ADDENDUM #2

March 3, 2022

Jeff Smith Park District of Highland Park 636 Ridge Road Highland Park, IL 60035

FOR: 2022 Moraine Park Path Improvements

SECTION AND DETAILS

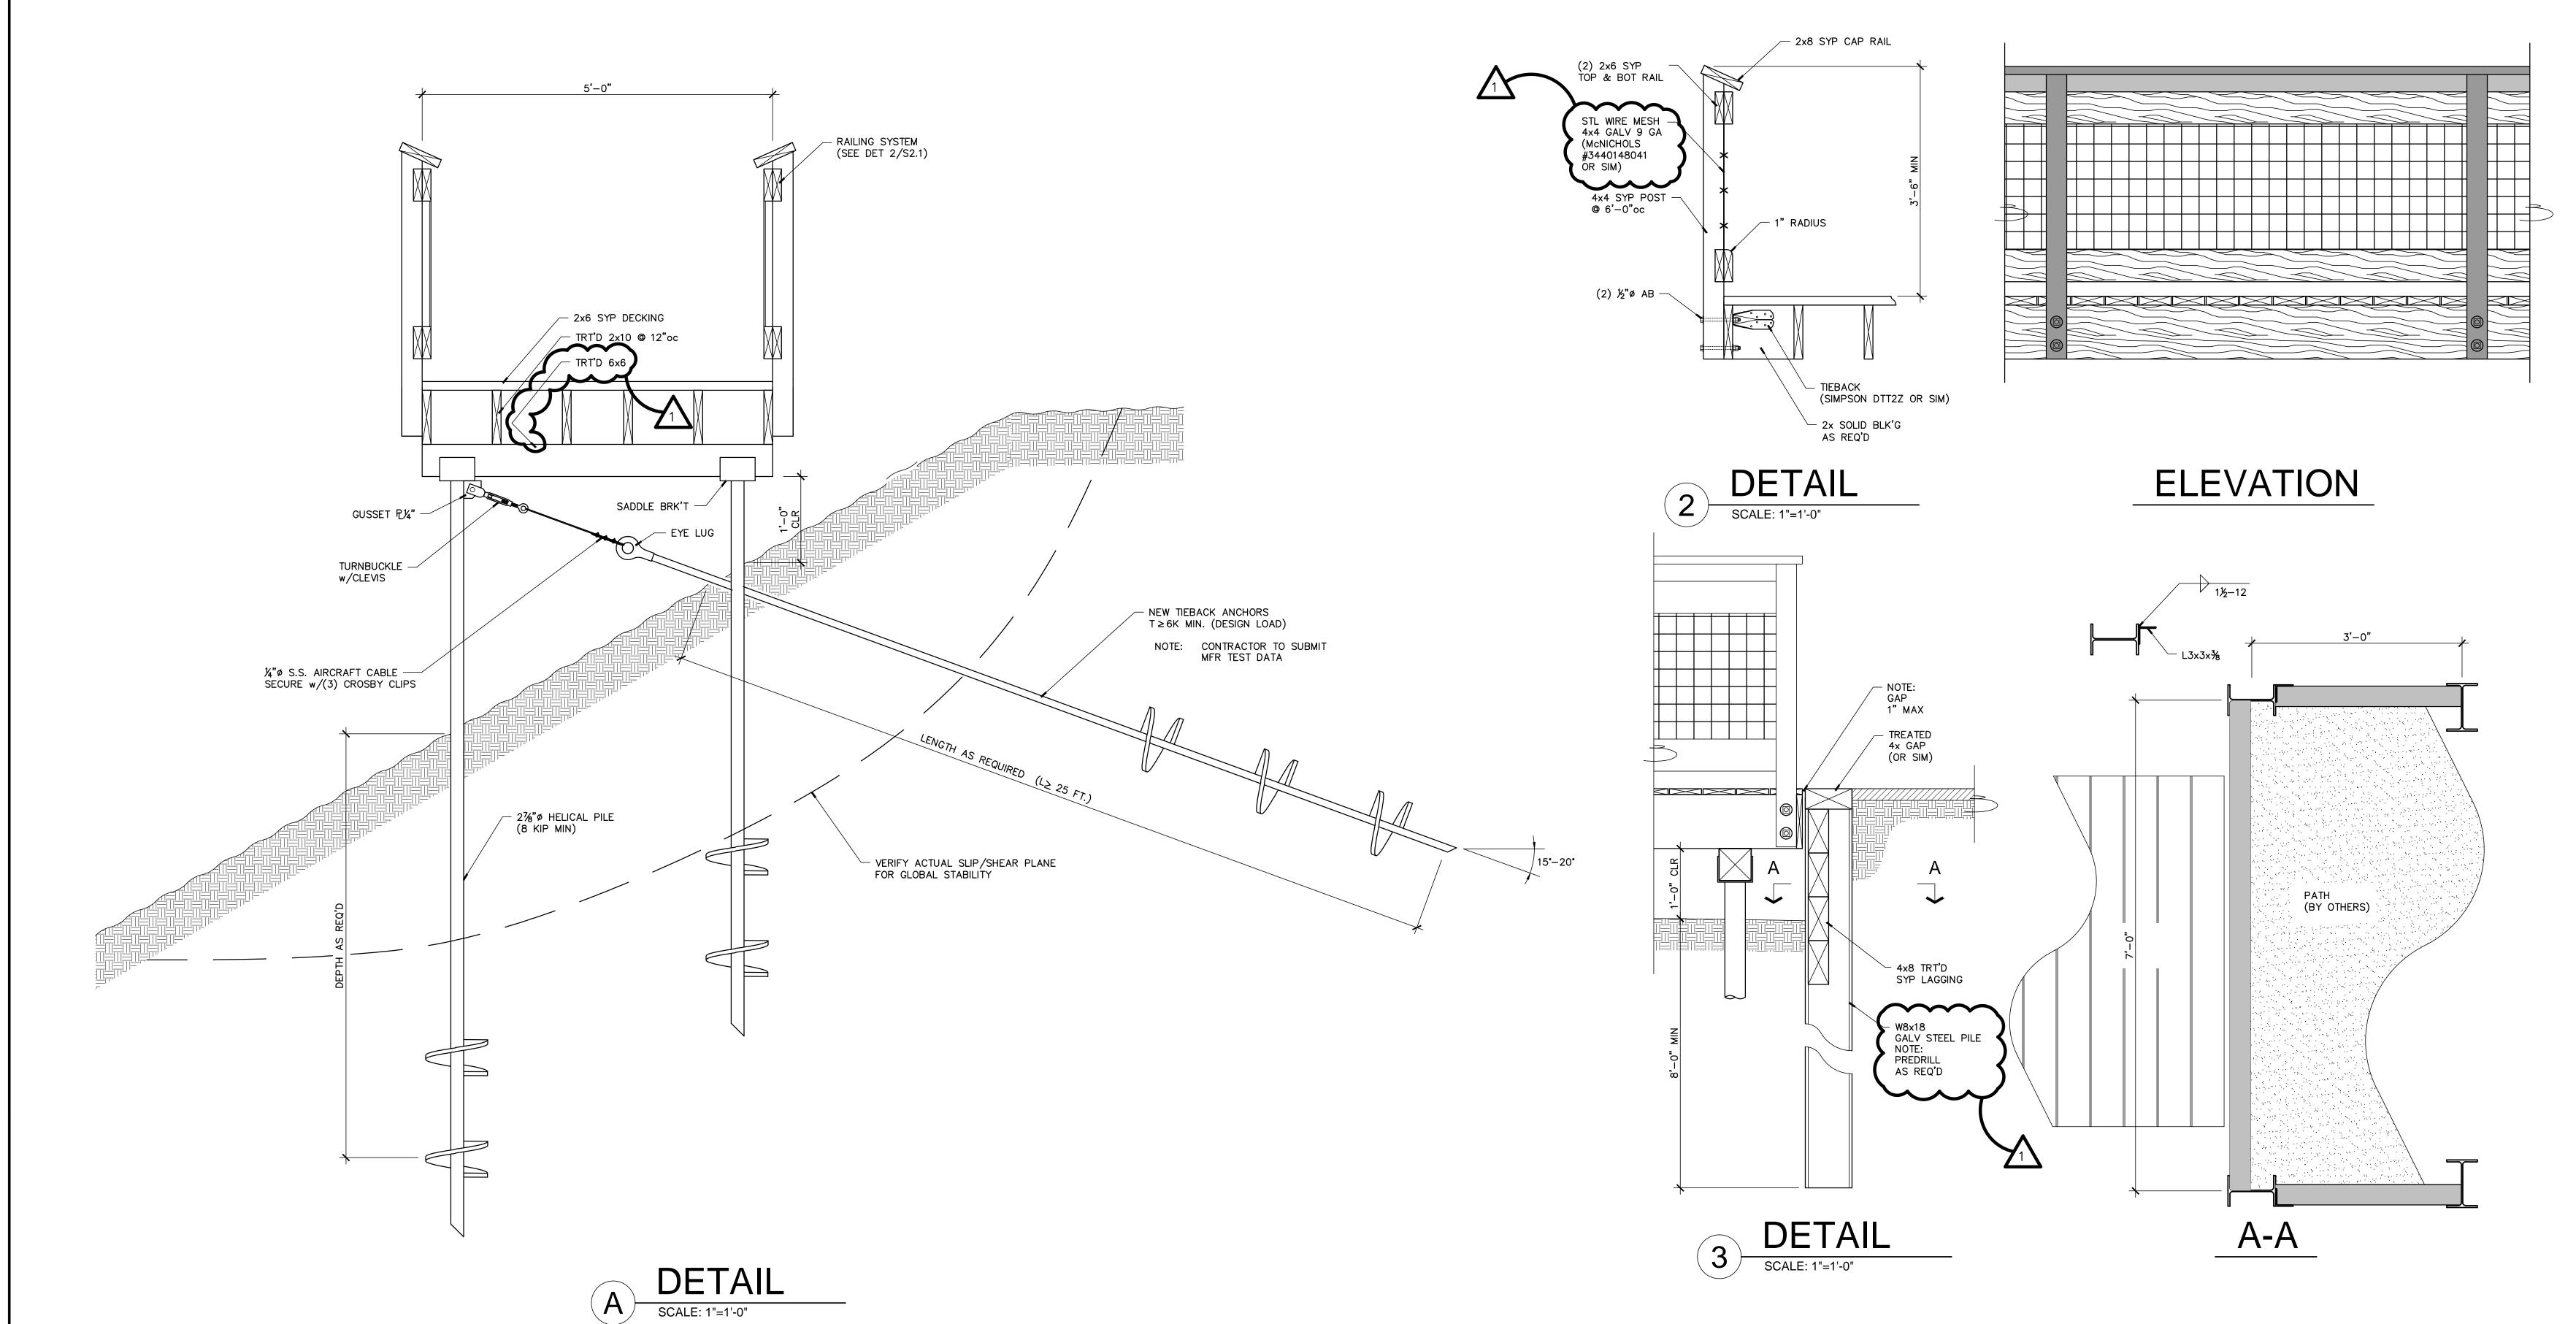
Sheet S2.1 – Detail 1 – Mention of Prefabricated Panels under the 2X10 Rim Boards call out, Please advise on these and their incorporation into the work.

Sheet S2.1 – Detail 3 – Please advise on any finishing coatings for the Steel 8X18 piles. Or are they left bare?

Sheet S2.1 – Detail 2 – Please advise on the gauge of the STL Wire Mesh for the railing. *See revised Sheet S2.1 attached.*

See revised Sheet S2.1 attached.

See revised Sheet S2.1 attached.
